### Vibration at Idle

E60 with N52K

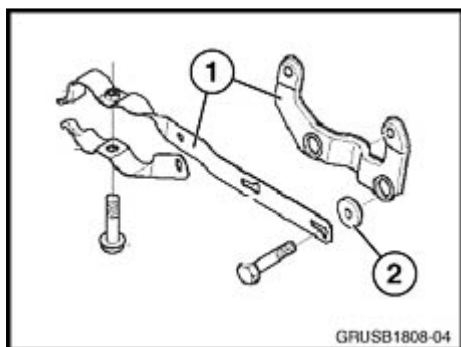
2. Remove the lower bracket for the exhaust system. If droning/vibration is gone, proceed to step three. If vibration/droning still exists with the lower bracket removed; continue troubleshooting exhaust/driveline for other causes or conditions

3. Remove complete bracket assembly and replace it with the bracket (1) PN 18 20 7 521 346 using two new ASA bolts (PN 07 12 9 905 417). Tighten to 21Nm.  
Install front pipe bracket (1) PN 18 20 7 521 347 with four rubber bushings (2) (PN 18 20 7 546 579) to the new 346 bracket with two ASA bolts (PN 07 12 9 904 559) and two nuts (PN 07 12 9 904 580). Tighten down to 21Nm

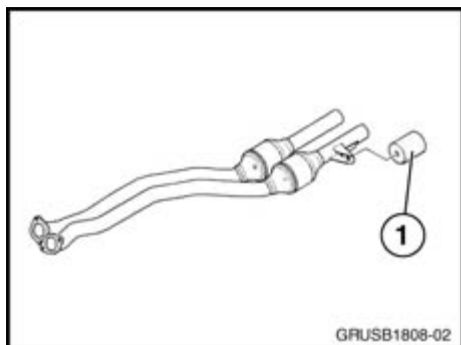
4. Replace the stock 88Hz exhaust vibration dampener

(1) with the 32hz dampener PN 18 10 7 506 145.  
Tighten to 21Nm.
